Mac-Tex Industries Ltd.

11 March 2024

1. Building Information

Observation-01: Foundation found to be stressed. (Production Building)

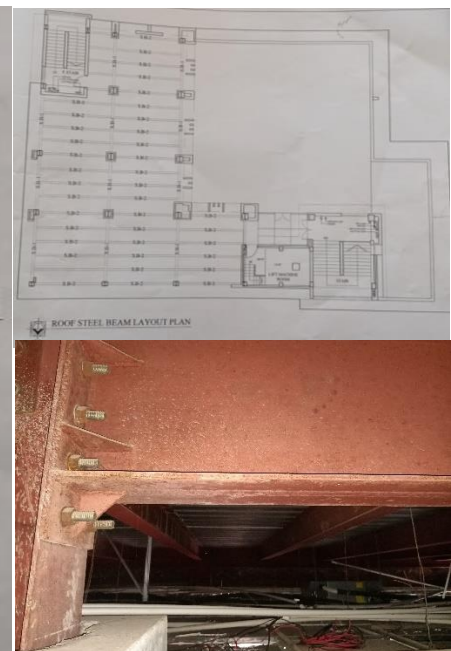
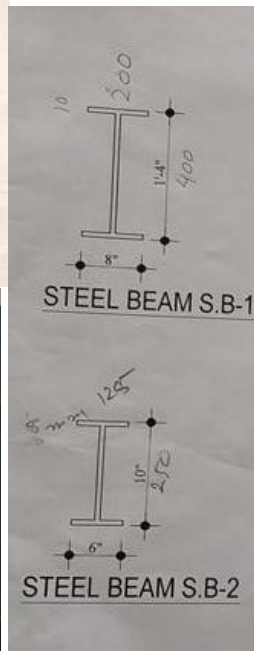
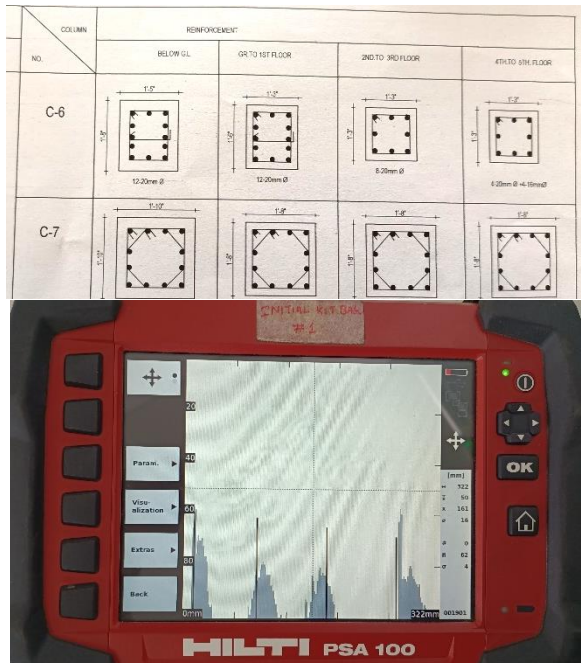
Description: Cursory calculation indicates the footing is stressed for Punching. The loading is considered 3 kPa for a typical floor and minimum concrete strength (16.3 MPa) based on aggregate type. The building engineer is required to verify in-situ material strength and review the design load and foundation stresses.
